Hyattsville Accessibility Transition Plan

Centennial Memorial Park

Centennial Memorial Park - Hyattsville Transition Plan

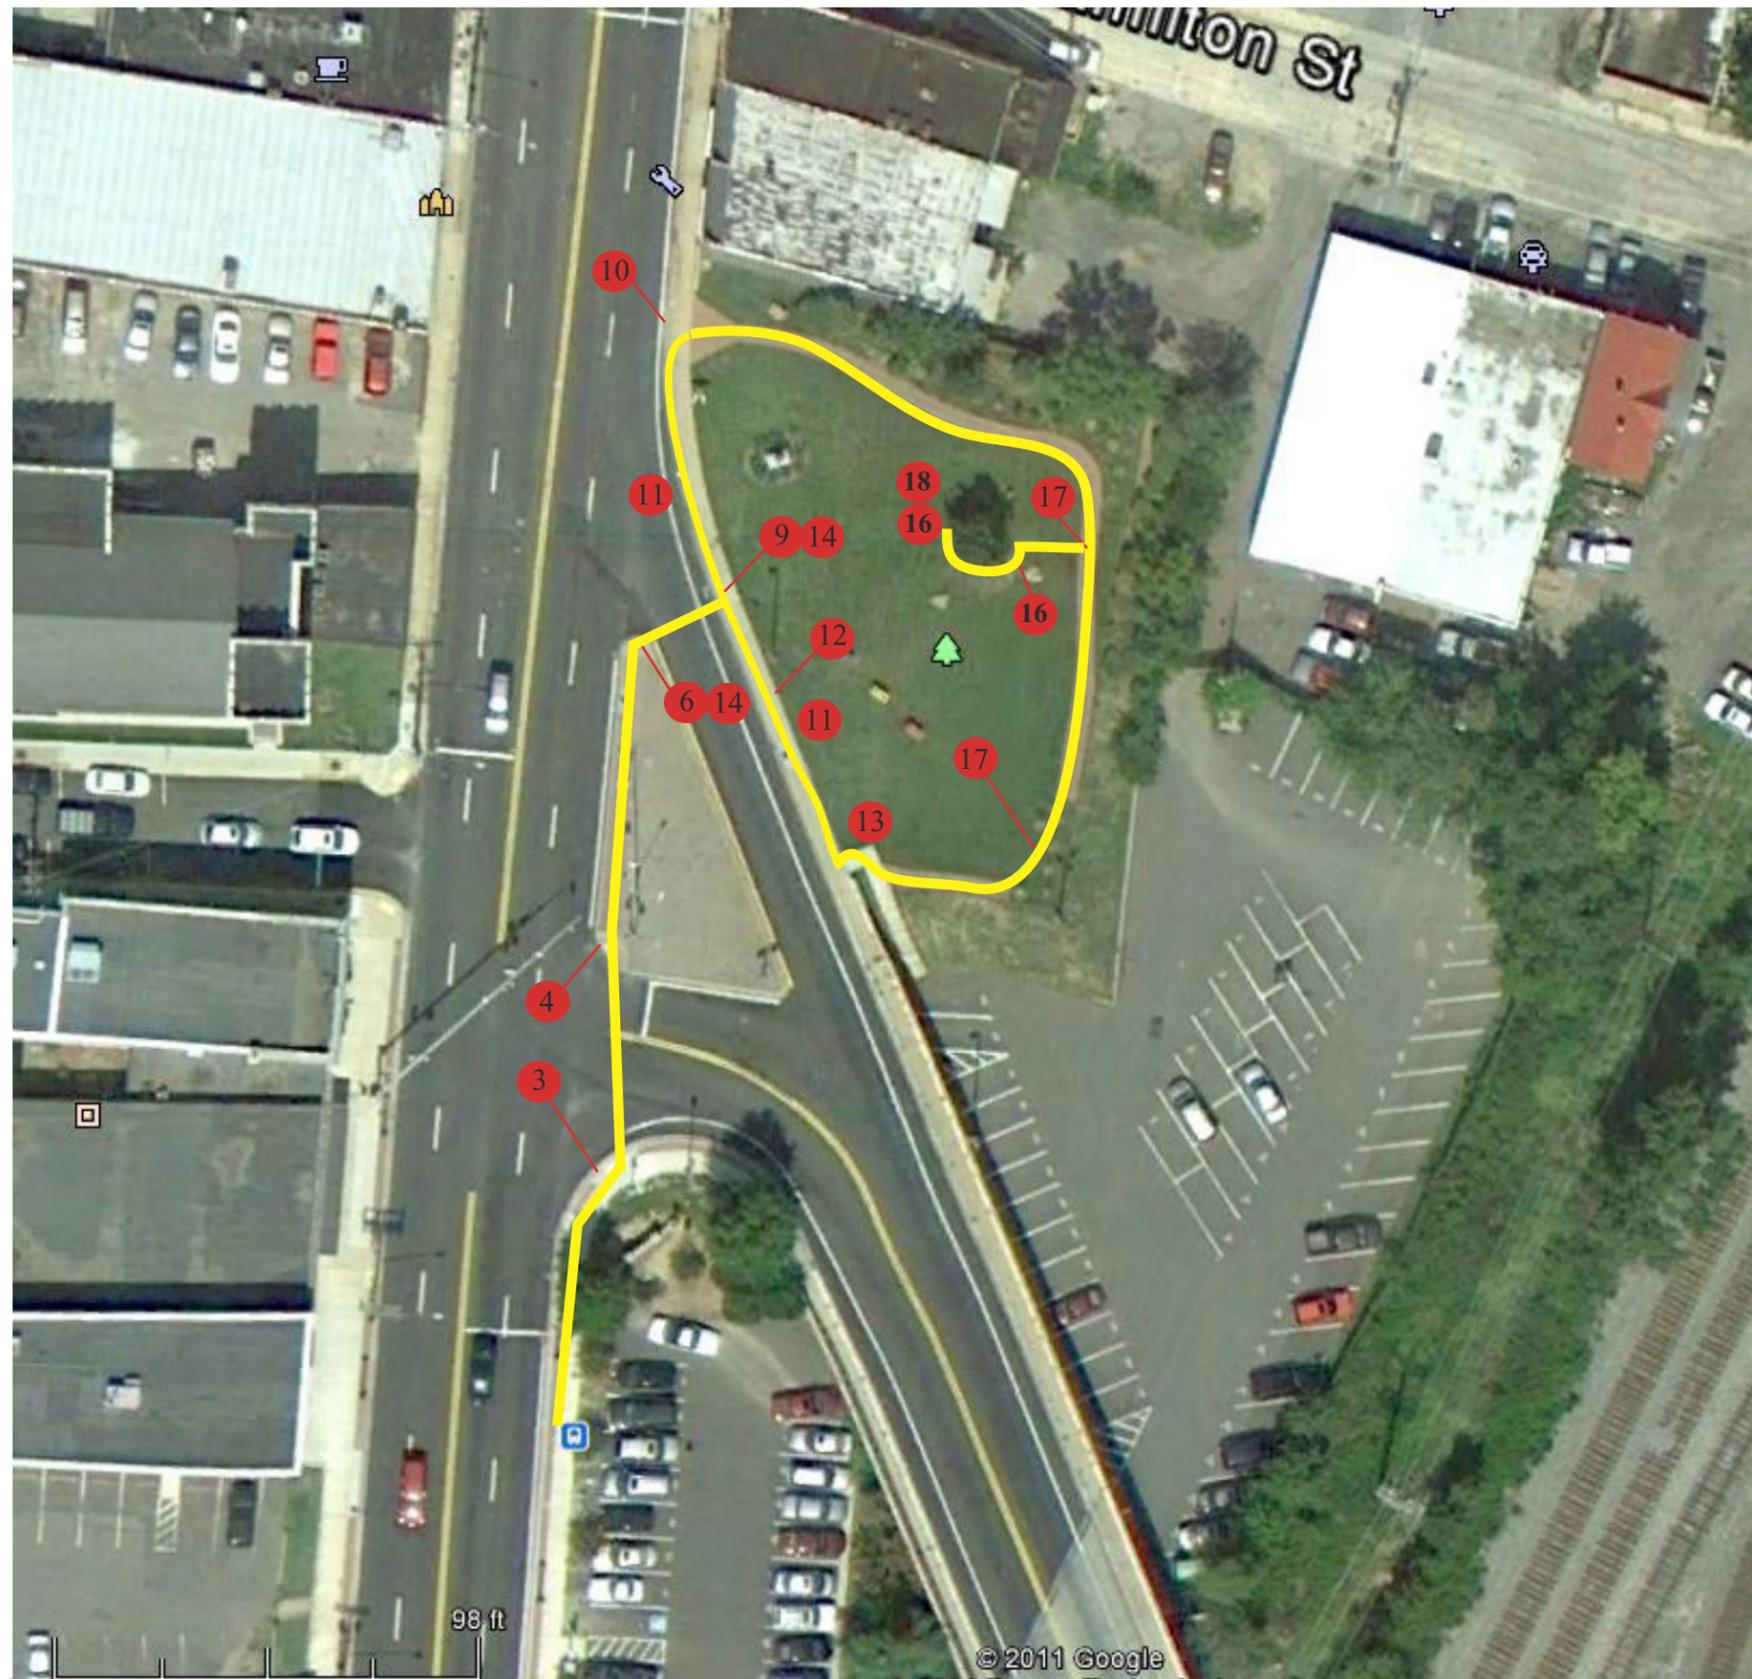
2010 Standards Citation	Description/Issue/Requirement	Non-Complying Item	Photos	Proposed Solution	Suggested Priority	Projected Cost MSHA	Projected Cost Hyattsville	Projected Cost Total	Projected Date	Action and Date
1											
2		Exterior Accessible Route from Bus Stop and Sidewalks to Park Entrance and Exit									
3	206.1, 406.2	Curb ramp is not a parallel type. Therefore, the gutter cannot counter slope more than 5%.	The gutter to the curb ramp at the corner of Baltimore Avenue and Alternate Rt. 1, has a counter slope of 7.7%.	2416, 2417	Corrections are the responsibility of Maryland State Highway Administration (MSHA). Rebuild portion of the gutter.	1	\$ 750		\$750		
4	206.1, 406.1	Slope of curb ramp cannot exceed 8.33%.	At the curb ramp on the south side of the traffic island, opposite the corner of Baltimore Avenue and Alternate Rt. 1, the slope on the curb ramp is 14.6%.	2418, 2419	Corrections are the responsibility of Maryland State Highway Administration (MSHA). Rebuild as a Type D ramp with a slope no more than 8.33% and flared sides no more than 10%.	1	\$ 4,150		\$4,150

5	206.1, 406.3	The built-up curb ramp as a flared side. It cannot slope more than 10%.	The flared side at the curb ramp on the south side of the traffic island, opposite the corner of Baltimore Avenue and Alternate Rt. 1, has a slope of 12.7%.	2424, 2425	Corrected with solution for item 4	1	See item 4		\$0		
6	206.1, 403.5	Curb ramp must be at least 36" wide.	The curb ramp on the north tip of the traffic island, opposite the corner of Baltimore Avenue and Alternate Rt. 1, is only 33" wide.	2432	Corrections are the responsibility of Maryland State Highway Administration (MSHA). Rebuild as a Type B ramp to be 36" wide minimum, with a slope no more than 8.33% and a gutter counter slope of no more than 5%.	1			\$0		
7	206.1, 406.1	Slope of curb ramp cannot exceed 8.33%.	At the curb ramp on the traffic island opposite the park entrance, the slope on the curb ramp is 12.8%.	2433, 2434	Corrected with solution for item 6	1	See item 6		\$0

8	206.1, 406.2	The transition between the curb ramp and the gutter cannot be abrupt.	At the curb ramp on the traffic island opposite the park entrance, the transition to the asphalt vehicular surface from the concrete gutter is taller than 1/2".	2431, 2432	Corrected with solution for item 6	1	See item 6		\$0		
9	206.1, 406.1	Slope of curb ramp cannot exceed 8.33%.	At the curb ramp on Baltimore Avenue, opposite the north tip of the traffic island, the slope on the curb ramp is 16.7%.	2440, 2441	Corrections are the responsibility of Maryland State Highway Administration (MSHA). Rebuild as a Type A ramp with a slope no more than 8.33%.	1	\$ 4,150		\$4,150

2010 Standards Citation	Description/Issue/Requirement	Non-Complying Item	Photos	Proposed Solution	Suggested Priority	Projected Cost MSHA	Projected Cost Hyattsville	Projected Cost Total	Projected Date	Action and Date
10	206.1, 403.3	Accessible route cannot have a cross slope that is more than 2%. Where the accessible route turns the cross slope is measured in two directions.	The curb ramp directly at the entrance path to the park has a cross slope where one turns to enter the park of and has a slope of 10.2%.	6962, 6963	Corrections are the responsibility of Maryland State Highway Administration (MSHA). Since this ramp is not required by the accessible route (there is no crosswalk at this location) it's recommended to demolish the ramp and provide a new sidewalk in this location.	15	\$ 2,000		\$2,000		
11	206.1, 303.4	Changes in level that are more than 1/2" require a ramp, platform lift, or elevator.	In the sidewalk, along the accessible route between the curb ramp opposite the north tip of the traffic island, and the park entrance, there are changes in level at the concrete joints of more than 1/2" that are not ramped.	2450, 2451	Corrections are the responsibility of Maryland State Highway Administration (MSHA). Repair portions of the sidewalk to be level along accessible route.	10	\$ 4,950		\$4,950

12	206.1, 403.3	Accessible route cannot have a cross slope that is more than 2%.	Along the sidewalk along the accessible route between the park exit (next to staircase) and the curb ramp on Baltimore Avenue, opposite the north tip of the traffic island,, the walkway has a cross slope that is 3.2%.	6956, 6957	Corrections are the responsibility of Maryland State Highway Administration (MSHA). Repair portions of the sidewalk to have a cross slope no greater than 2.0% along accessible route.	10	\$ 1,320		\$1,320		
13	206.1, 303.4	Changes in level that are more than 1/2" require a ramp, platform lift, or elevator.	In the sidewalk, along the accessible route between the park exit (next to staircase) and the curb ramp on Baltimore Avenue, opposite the north tip of the traffic island, there are changes in level at the brick and concrete joints, of more than 1/2" that are not ramped.	6945, 6958, 6959	Corrections are the responsibility of Maryland State Highway Administration (MSHA). Repair portions of the sidewalk to be level along accessible route. Sidewalk will need to be leveled with respect to the storm water structure in the sidewalk.	10	\$ 1,000		\$1,000

14		While not a requirement of the DOJ 2010 ADA Standards, detectable warnings are required by MDOT on new construction for curb ramps in the public right of way.	The curb ramps in the right of way do not have detectable warnings at the pair of ramps at the north tip of the traffic island and opposite.	2433, 2447, 2450	Corrections are the responsibility of Maryland State Highway Administration (MSHA). Provide a detectable warning at the two curb ramps at the north tip of the traffic island and opposite.	20	\$ 500		\$500

2010 Standards Citation	Description/Issue/Requirement	Non-Complying Item	Photos	Proposed Solution	Suggested Priority	Projected Cost MSHA	Projected Cost Hyattsville	Projected Cost Total	Projected Date	Action and Date
15		Exterior Accessible Route from Park Entrance to Park Features:							\$0		
16	206.1, 302.1	Accessible route must be firm, stable, and slip resistant.	The route from the park walkway to the Memorial Tree and Natural Rock Seating is not paved and therefore not accessible.	2456	Provide an accessible route to the Memorial Tree Signage and to the seating areas by constructing an accessible sidewalk. Provide a wheelchair accessible seating space at the seating area. Included are costs to provide a brick sidewalk over concrete base, to match the existing sidewalk.	25		\$6,000	\$6,000		
17	206.1, 403.5.3	An accessible route with a clear width less than 60 inches shall provide passing spaces at intervals of 200 feet maximum.	The brick pathway is 48" wide and longer than 200', and does not have any areas 60" wide for passing or turning around.	2453, 2454, 2455	Provide turn around areas every 200 lf, which can be accomplished by providing a minimum 5'x 5' area at the junction of the new sidewalk in item 15. Complete existing walkway to connect to public sidewalk (missing a piece).	25		\$2,900	\$2,900

18	216.3, 703.5.1	The characters on signs that provide direction to or information about functional spaces must be a non-glare finish and contrast with the background, either light on dark or dark on light.	The directional signage at the memorial tree has shiny bronze characters.	2457, 2458	Provide additional new signage at Memorial Tree.	25		\$400	\$400		
19					Total				\$28,120		
20					Total MSHA		\$ 18,820				
21					Total Hyattsville			\$9,300			
22											
23					Priority 1 - 4:		\$9,050	\$0	\$9,050		
24					Priority 5 - 9:		\$0	\$0	\$0		
25					Priority 10 - 14:		\$7,270	\$0	\$7,270		
26					Priority 15 - 19:		\$2,000	\$0	\$2,000		
27					Priority 20 - 25:		\$500	\$9,300	\$9,800		
28					Total		\$18,820	\$9,300	\$28,120
